# LiDAR Quality Assessment Report

GA\_SeventeenCoGAHyFlat\_2\_2011

Seventeen County GA Hydro Flattening\_...

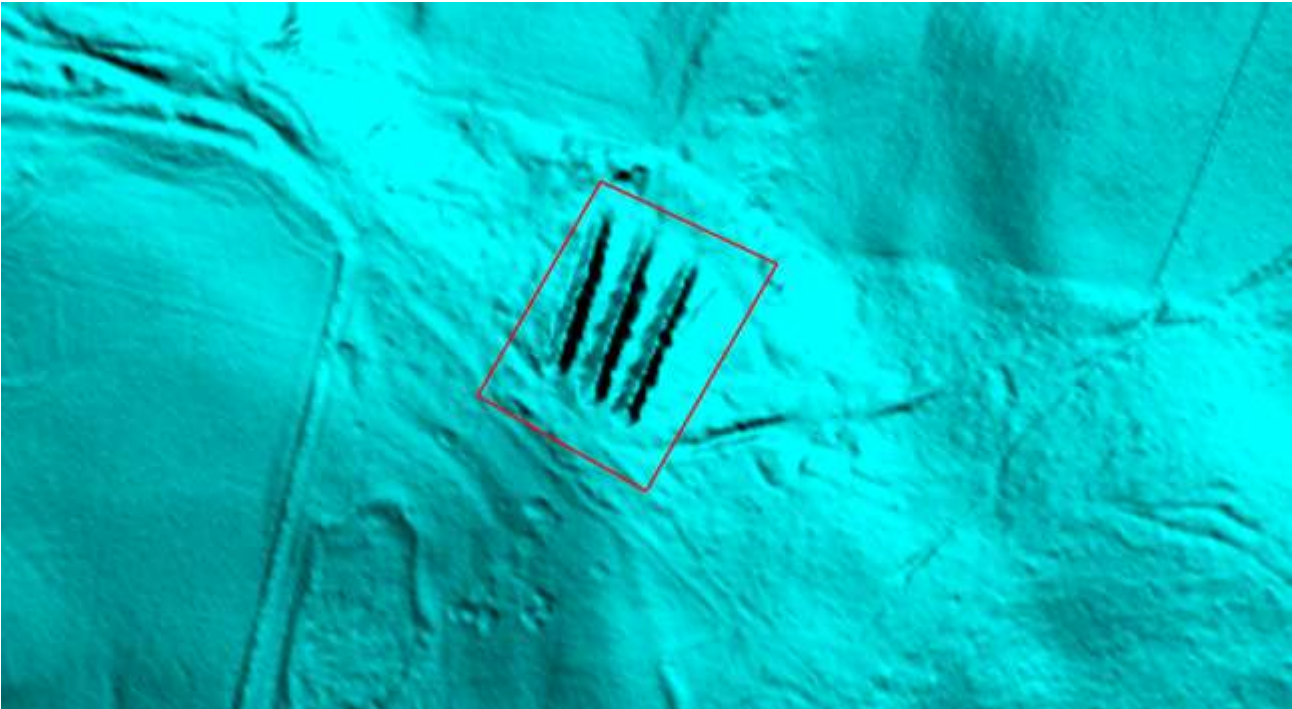
Ground anomaly. May not be an error but these ground conditions can not be verified by NGTOC due to tree cover in this area.  
32° 47' 32.5993" N, 81° 37' 25.3324" W
